**TECHNICAL BULLETIN**  
**014**  
**December 2016**

Check valve cages p.n. 1407.51

## TECHNICAL BULLETIN 014 Dicembre 2016

### Raccordo codici 1407.51

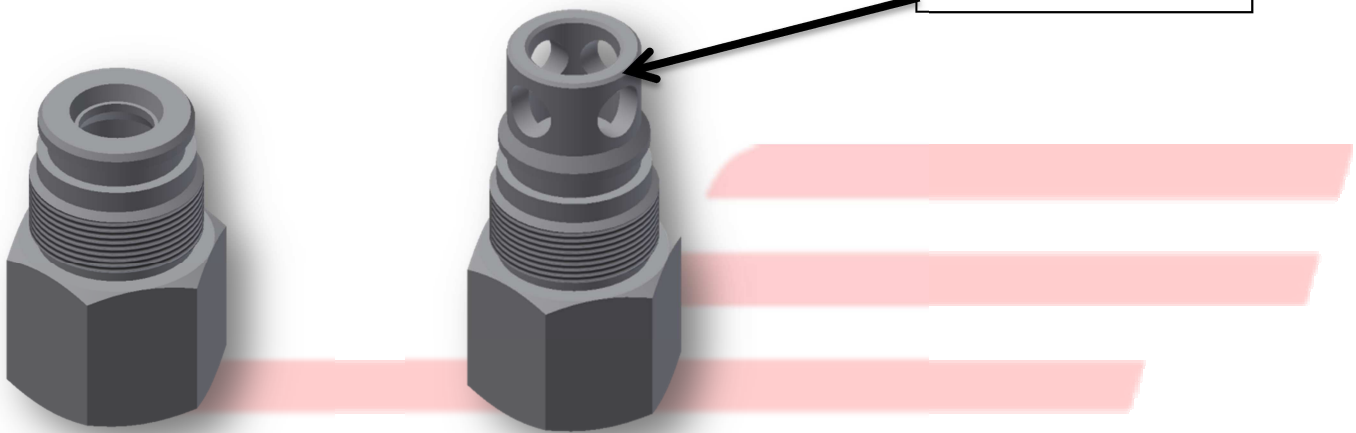
*1407.51 was*

*1407.51 is*

ADDED "CAGE"

*The fitting has been modified to improve the durability of the valve seat components in case of large flow rate in by-pass.*

*The new fitting is interchangeable with the old.*

*Other parts of the valve are not changed.*

*The part numbers remain the same.*

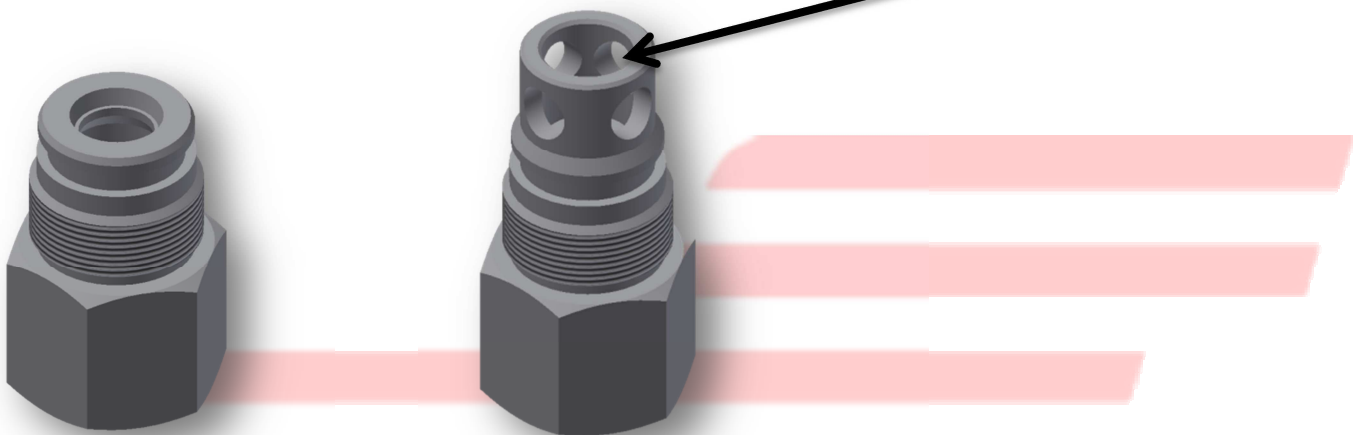
1407.51 era

1407.51 è

AGGIUNTA "GABBIA"

Il raccordo è stato modificato per migliorare la durata dei componenti della sede valvola nel caso di portata in larga parte in by-pass.

Il nuovo raccordo è intercambiabile con il vecchio.

Le altre parti della valvola non sono cambiate.

I codici rimangono gli stessi.
